# City of Del Mar Staff Report

TO: Honorable Mayor and City Council Members

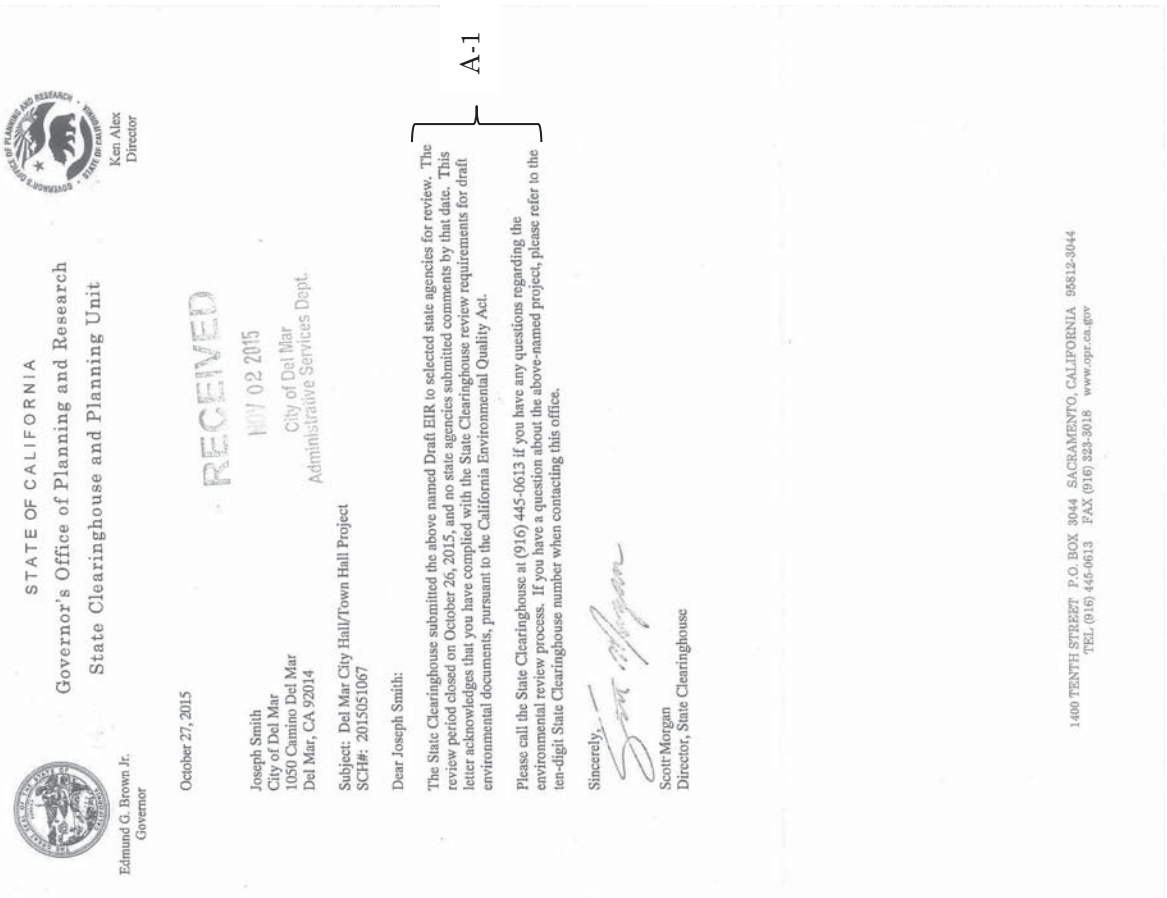
## DEL MAR CITY HALL/TOWN HALL PROJECT FINAL EIR LETTERS OF COMMENT AND RESPONSES

A copy of each comment letter along with corresponding staff responses is included here. Some of the comments did not address the adequacy of the environmental document; however, staff has attempted to provide appropriate responses to those comments where information may have been gleaned from the EIR. Comment letters are numbered based on the order received, with the exception of the letter from the State Clearinghouse. Some of the comments received resulted in changes or additional information to further clarify the analysis contained within the EIR. These changes are indicated by ~~strikeout~~ (deleted) and underline (inserted) markings in the Final EIR.
